Amendments to the Drawings:

REMARKS

"SEAT LOAD MEASURING APPARATUS"

S.N. 10/822,706

Fig. 3(B)

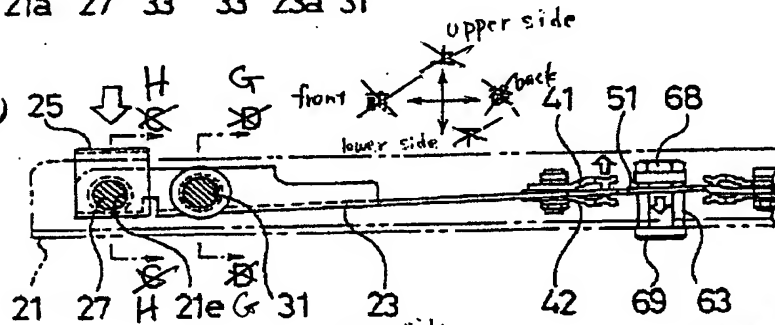
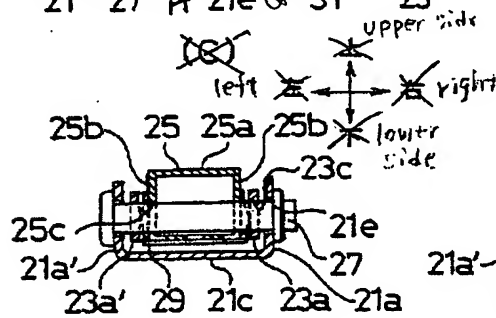
The drawings have been objected to because the reference characters "C-C" and "D-D" have been used to designate cross-sections in FIGS. 2(B), 3(B), and 6(B) and cross-section designations can only be done for one picture at a time. Amended drawings have been submitted in which the cross-section designations in FIGS. 3(B) and 6(B) have been changed. Annotated drawings have also been submitted showing the changes.

The drawing sheets attached in connection with the above-identified application containing Figures 3(A) to 3(B), 5(A) to 5(B), and 6(A) to 6(D) are being presented as sheets to be substituted for the previously submitted drawing sheets. Figures 3(B) and 6(A) to 6(D) have been amended. Appended to this amendment is an annotated copy of the previous drawing sheet, which has been marked to show changes presented in the replacement sheet of the drawing.
